Bulletin no.: ALG210001  
Date: 10-02-2021  
Subject: Service injector GEN-I V20

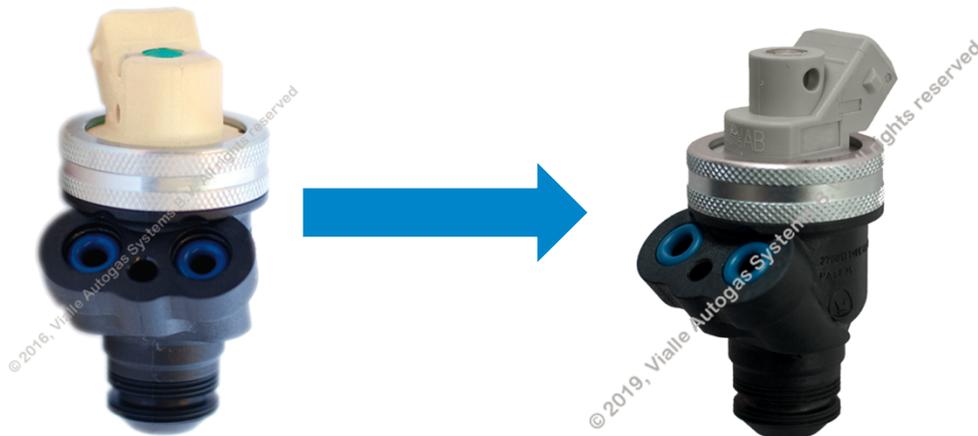
As of today, we are going to replace the GEN-I V20 (White) injector for the GEN-II K20 (Grey) injector for the service of the LPi- and LiquidSi systems. The GEN-I V20 injector production has been stopped and these injectors are running out of stock. The K20 injector has an identical capacity, that's why the calibration settings don't need adjustments.

**Note:** Replacing just one V20 injector with a K20 on a system is not recommended, due to the different electrical character. The electrical resistance of the K20 injector is higher ( $6\Omega$ ) compared to the V20 ( $1.5\Omega$ ).

Another important difference is the location of the sealing O-rings which is slightly different. Therefore, the housing of the new and old injector is **NOT** interchangeable!
